PRODUCT SUPPORT BULLETIN BULLETIN NO. 337

MACHINE: 18-Ton Crane

SUBJECT: Swing Drive Retrofit Kit – 840070

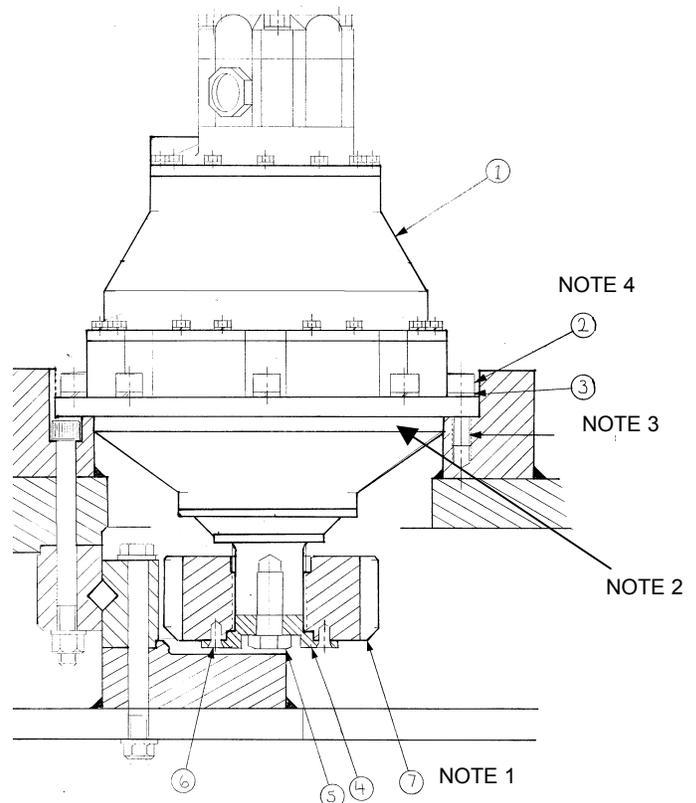
This Swing Drive Retrofit Kit will replace the original Swing Drive, p/n F-230, with a new, more readily available drive. The **Swing Drive Retrofit Kit, p/n 840070**, includes a new **Drive Assembly, p/n F-411**, and all required hardware and instructions.

1. Drive Gear, p/n C-22307, will be fixed to the shaft by Step Plate, p/n 840071, and secured by one (1) 1" x 2" NF Grade 8 capscrew & four (4) 3/8" x 1" Flat Head Machine Screws. Apply Loctite #242 (blue).
2. Drive F-411 will be mounted to the lower step as shown. The pilot diameter of the motor is 14.000/13.997". It may be necessary on some cranes to machine down the pilot diameter of the motor to allow it to fit into the pilot hole.
3. Drill 8 holes .65 dia. X 2.375 deep; tap 3/4-10 (2B), 1.625 deep on 15.50 dia. Bolt circle. Chamfer .094" x 45°.
4. Secure Drive with eight (8) 3/4" x 2-1/4" Socket Head Capscrews and high collar lock washers.
